# BCA ASSESSMENT REPORT

1B Bolingbroke Parade, Fairlight NSW 2094

**Prepared for:** Robbie Treharne / **Project No.:** 180538

**Date:** 11 April 2020 / **Status:** Revision 3

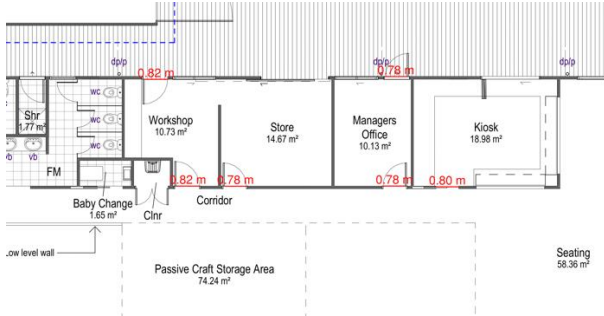
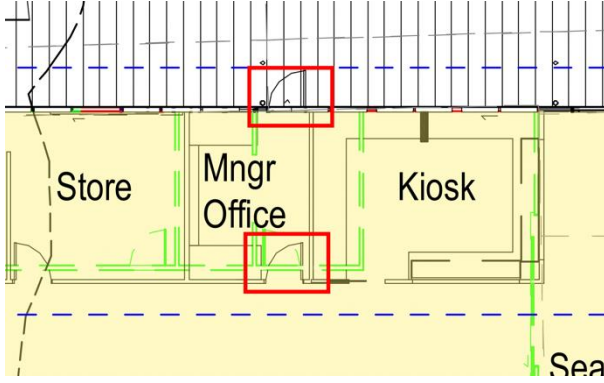
<p>BCA Clause C3.2- Protection of Openings in External Walls</p>	<p>An opening in an external wall that is required to have an FRL must be protected in accordance with Clause C3.4 if the opening is located within 3 metres of a side or rear allotment boundary or 6 metres from the far boundary of a road if not located in a storey at or near ground level.</p> <p>It is recognised that the subject building is located across two allotments (being Lot 2699 in Deposited Plan 752038 and Lot 1 in Deposited Plan 858156), as such the building has a number of openings that are located within 3 metres of an "allotment boundary" (see Figure below).</p> <p>In this regard, it is recommended that all openings located within 3 metres of an allotment boundary to the ground floor level (Class 5 and 6 part) and all openings located within 1.5 metres to the first floor level residential apartment (Class 4) be protected in accordance with the requirements of Clause C3.4 of the BCA, or a Performance Solution be prepared by a C10 Fire Safety Engineer in accordance with Performance Requirement CP2 of the BCA.</p> <p><u>Note:</u> There is no exposure between the kiosk and the passive craft storage shed as the building has been classified as a Class 10a building and therefore is not required to be protected in accordance with Clause C3.4 as referenced in Clause C3.2 (a) (iii).</p> <div data-bbox="687 1615 1281 2056"> </div>

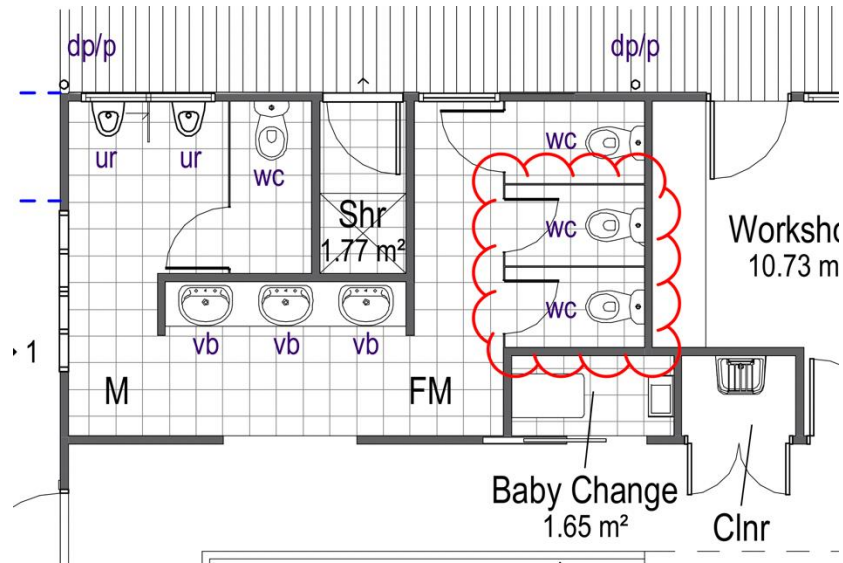
<p>BCA Clause D1.4: Exit Travel Distances</p>	<p>Class 4 parts of a building –</p> <p>The entrance doorway to any Class 4 part of a building must be not more than 6 metres from an exit or a point from which travel in different directions to 2 exits is available.</p> <p>The architectural plans indicate a distance of 7.04 metres from the sole occupancy entrance doorway to open space.</p> <p>In this regard, a re-design is to occur to indicate the entrance doorway of the Sole Occupancy Unit not to be more than 6 metres from Open Space or a Performance Solution is to be prepared by a C10 Fire Safety Engineer in accordance with Performance Requirement CP2 and EP2.2 of the BCA.</p> 
<p>BCA Clause D1.6: Dimensions of Exits and Paths to Travel to Exits</p>	<p>In accordance with this Clause of the BCA, in a required exit or path of travel to an exit the unobstructed width of each exit or path of travel to an exit (except for doorways) must not be less than 1 metre.</p> <p>It is recognised that the opening to the workshop and path of travel within the female toilets decrease below one (1) metre.</p> <p>In this regard, design changes are required to indicate a minimum path of travel of one (1) metre throughout the subject building or a Performance Solution is to be prepared by a C10 Fire Safety Engineer in accordance with DP6 and EP2.2 of the BCA.</p>

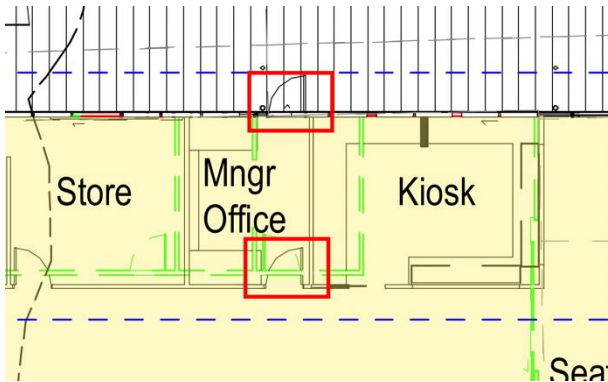
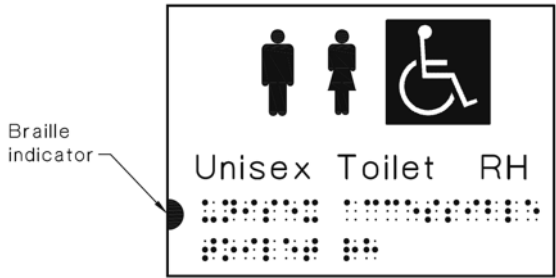
D2.16: Barriers to Prevent Falls	<p>A continuous barrier must be provided along the side of –</p> <ul style="list-style-type: none"> <li>(v) A roof to which general access is provided; and</li> <li>(vi) A stairway or ramp; and</li> <li>(vii) A floor, corridor, hallway, balcony, deck, verandah, mezzanine, access bridge or the like; and</li> <li>(viii) Any delineated path of access to a building.</li> </ul> <p>If the trafficable surface is 1 m or more above the surface beneath.</p> <p>A required barrier under this Clause must have a height of not less than 1 metre in height measured above floor and landings and not more than 865mm above the stair nosings. In addition, there must be no gaps in the balustrade that would permit a 125mm sphere from passing through any point.</p> <p>It is recognised that the architectural plans do not indicate a barrier to the deck and pontoon (see 3D perspective below) which provides a delineated path of access to the subject building.</p> <p>Preliminary discussions have been held with a BCA Consultant as to advise as to whether there is a scope to address the departure from the BCA under a Performance Based Solution. In this regard, there may be scope for a Performance Solution drawing a comparison to that of a</p>	<p><b>PBS</b></p> <p><b>Refer to Part 5 of this report</b></p>

<p>Stage or Loading Bay which is exempted from having a barrier under the BCA.</p> <p>In this regard, the architectural plans are to be revised to indicate a barrier along each side of the deck and pontoon complying with this Clause or a Performance Solution is to be prepared by a qualified BCA Consultant in accordance with Performance Requirement DP3 of the BCA.</p> <p><u>Note 1:</u> It is considered that the pontoon, gangway, and deck are deemed a "delineated path of access to a building" and are therefore required to be provided with a barrier under this Clause.</p> <p><u>Note 2:</u> Balustrades are to meet the structural requirements under AS 1170 and be certified on completion by a Structural Engineer.</p>
